SAND POINTE ADDITION TO SEDGWICK COUNTY, KANSAS

S/D 98-62 - Final Plat of SAND POINTE ADDITION

STAFF REPORT

CASE NUMBER: S/D 98-62 - SAND POINTE ADDITION

SAND POINTE ADDITION TO SEDGWICK COUNTY, KANSAS

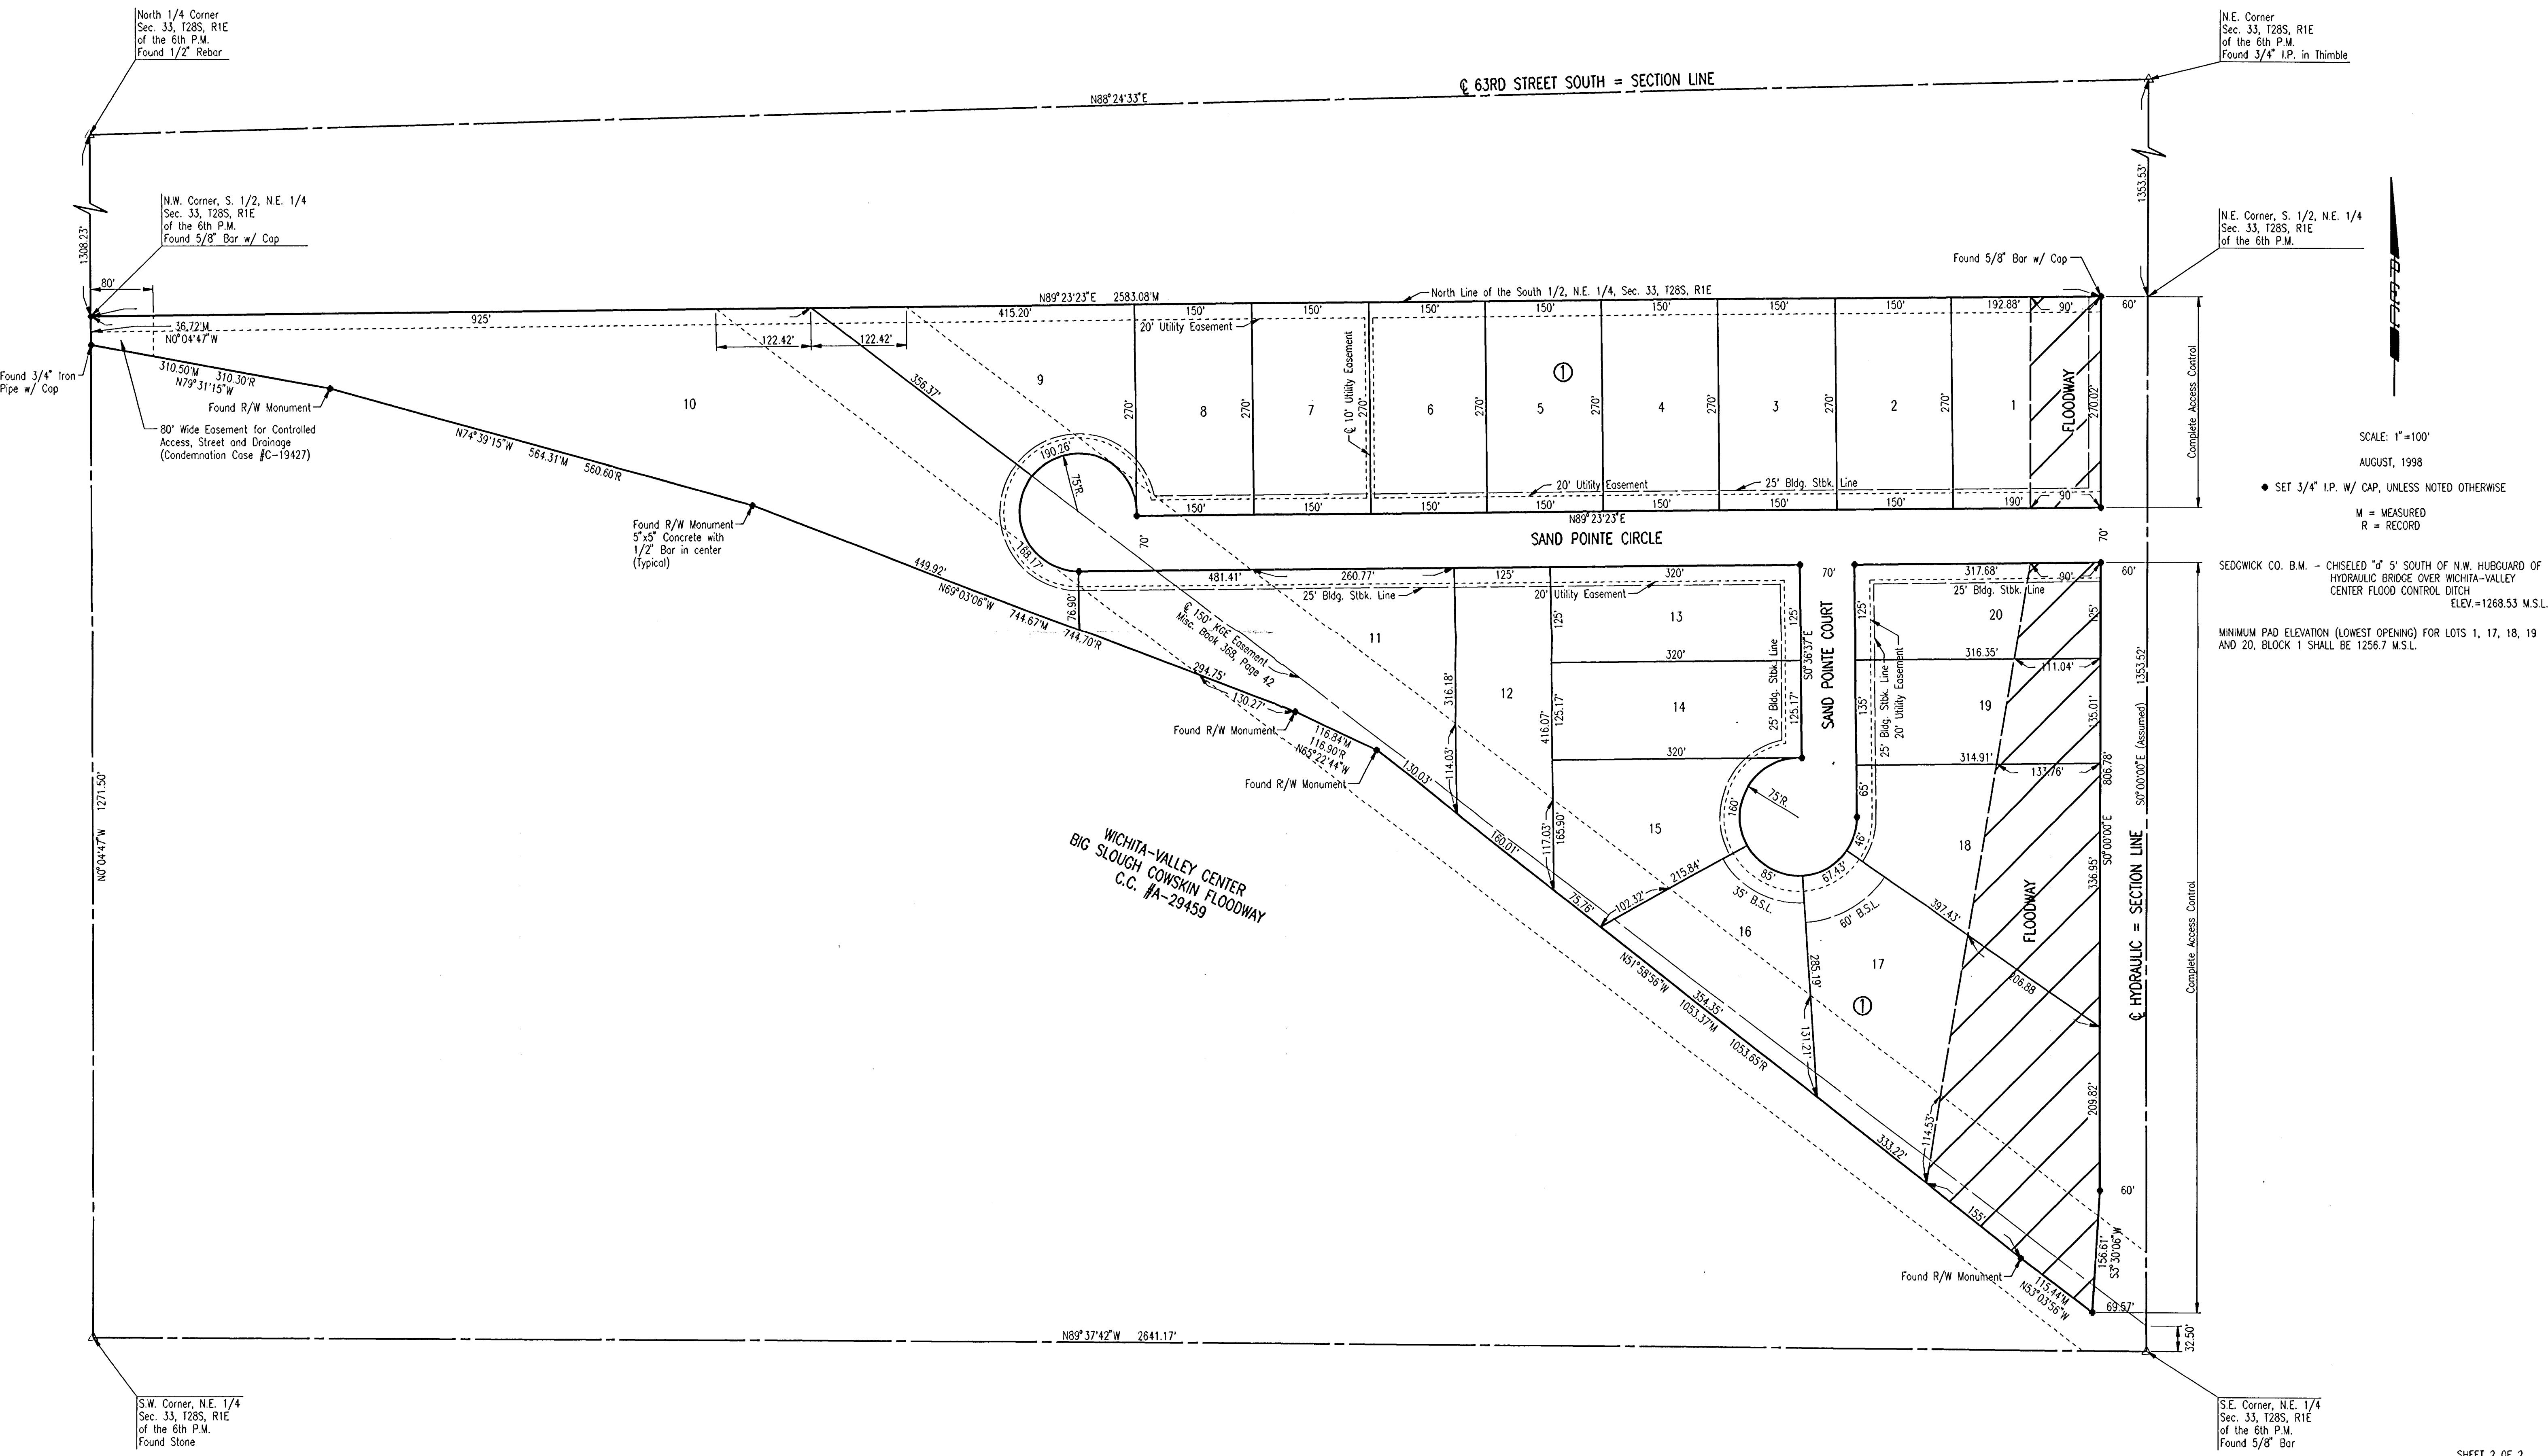
- C. County Engineering needs to comment on the status of the applicant's drainage plan. The drainage plan is approved.
- D. An increase in the distance of the building setback of Lot 17 is needed to meet the 100-foot lot width standard.

- E. Lots 10, 12, 13, 14, 18, 19, 20 do not conform with the lot depth to lot width ratio of 2.5 to 1, and a waiver would be needed if this plat is approved.

- F. **County Engineering** needs to comment on the need for improvements to Hydraulic. **No improvements to Hydraulic are needed. An additional 10 feet of right-of-way needs to be dedicated along Hydraulic.**

- The requested dedication has been denoted on the final plat.
- G. **County Engineering** and **Fire Department** need to comment on the length of Sand Pointe Circle (1320 feet) which exceeds the 600 foot maximum imposed by the Subdivision Regulations. **Fire Department has approved the street length.**

The additional setback has been denoted on the final plat.
